HOLDOVER

Revised

THE ROCK CHURCH SUBDIVISION

APPLICATION NUMBER Holdover DATE November 17, 2005
APPLICANT The Rock Church Subdivison
REQUEST Subdivision

THE ROCK CHURCH SUBDIVISION

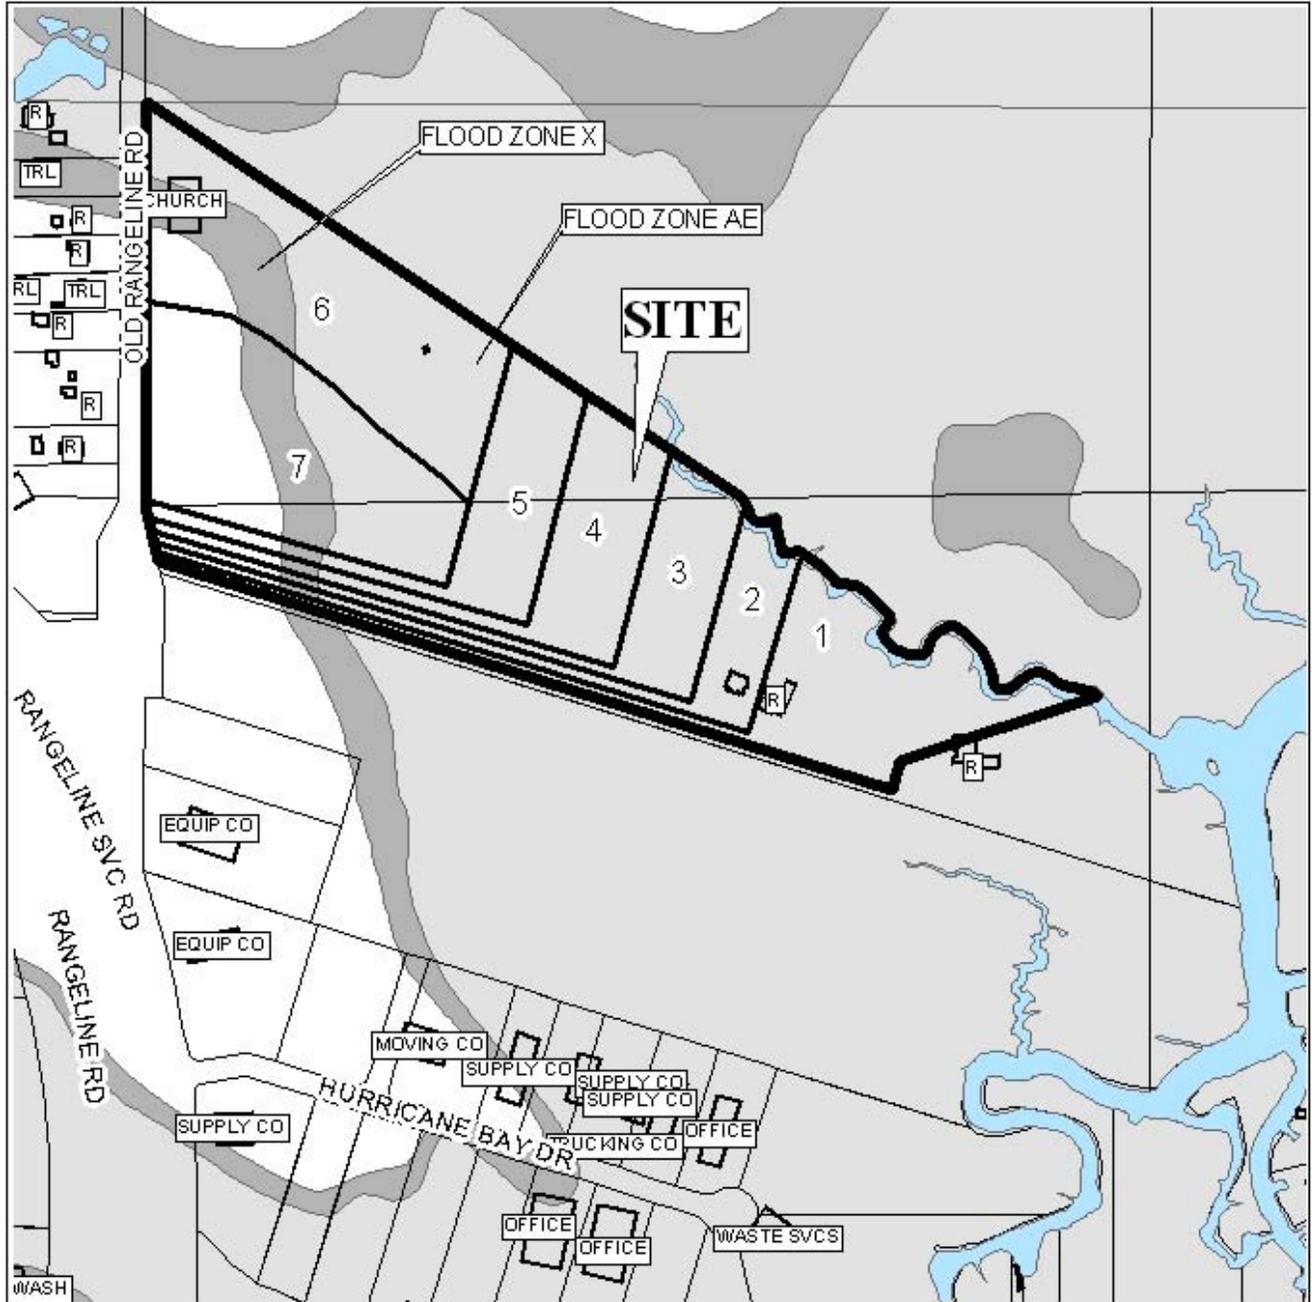
Lots 1- 5 are proposed to be flag-lots with 25-foot wide strips ranging from approximately 741 feet to 1,626 feet in length, connecting them to Old Rangeline Road. If the "pole" portion of the flag-lots is excluded, all proposed lots meet the recommended depth to width ratios of Section V.D.3. Lots in the vicinity of Alligator Bayou exhibit high depth to width ratios due to the desirability of waterfront lots and the extensive wetlands in the area. Flag-lots exist along the Alligator Bayou / Dog River area, however, they create an undesirable land subdivision condition which, in this case, could easily be remedied through the provision of a public street following the existing access road on the site, or via the creation of an innovative subdivision with a private street, in conformance with Section VIII. of the Subdivision Regulations.

The application was heldover to give the applicant the opportunity to redesign the proposed subdivision to eliminate the flag-lot configuration. The applicant has not submitted any information regarding redesigning the proposed subdivision to remove the proposed flag-lot configuration.

Based upon the preceding, the application is recommended for Denial for the following reasons: 1) the extreme flag-shaped nature of the proposed Lots 1-5 are uncharacteristic of other lots in the area, with the exception on the one adjacent flag-lot, and thus do not comply with Section V.D.1. of the Subdivision Regulations; and 2) the proposed Lots 1-5 exceed the maximum depth to width ratio identified in Section V.D.3. of the Subdivision Regulations.
